Access Compliance Report Public Rights-of-Way (Curb Ramps)

Main Street: **PIEDMONT_AVE** Cross Street: **ARGYLE_DR** Location: **SE**

ADA ID: **RPAT211206104621** Ramp Type: **Type 1 - Perpendicular** Initial Pass/Fail: **Pass** Overall Compliance: **No** Severity Score: **12**

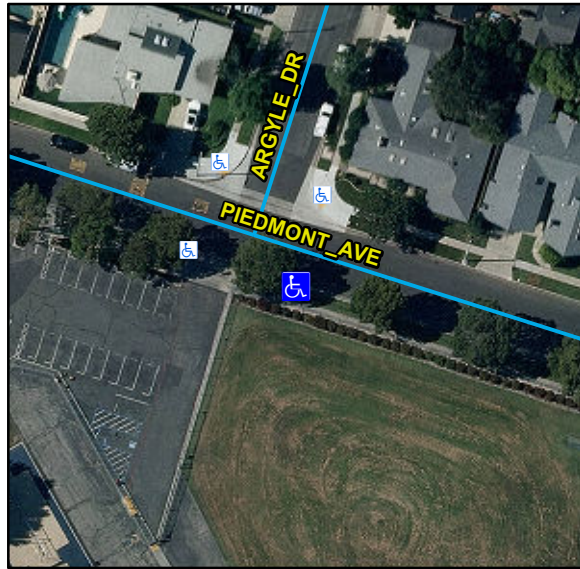
Unable to collect gutter info due to mud

R304.2.1, R304.2.2-Perp, R304.3.2-Para, R305, R302.7, R304.5.4, R304.5.3, STD 1115

Remove & Replace Entire Ramp. Remove & Replace Gutter.
